UNITED STATES PATENT AND TRADEMARK OFFICE

APPLICATION NO.	FILING DATE	FIRST NAMED INVENTOR	ATTORNEY DOCKET NO.	CONFIRMATION NO.
10/687,600	10/20/2003	Makoto Morishima	520.43227X00	2551

Office Action Summary

DETAILED ACTION

Fig. 6

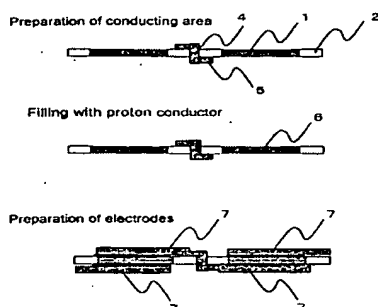
Figure 6 below of Kidai et al depicts a polymer electrolyte membrane comprising a plurality of electrodes 7 consisting of respective electrode substrates and electrocatalyst layers

(P.0058). Porous area 1 is filled with Nafion (EXAMPLE 1/ P0100-0103). *If porous area filled with Nafion represents the electrolyte membrane having slots, then, the pores are filled with Nafion which is an electron non-conductive material.*

Compounding the above teachings, it would have been obvious to a skilled artisan at the time the invention was made to use the specific insulating sealant of Kidai et al at the specific location in the chemical cell of Choi as Kidai et al teach that an electron non-conductive material is suitable for filling the slots/openings in a membrane. In this instance, the use of an insulating
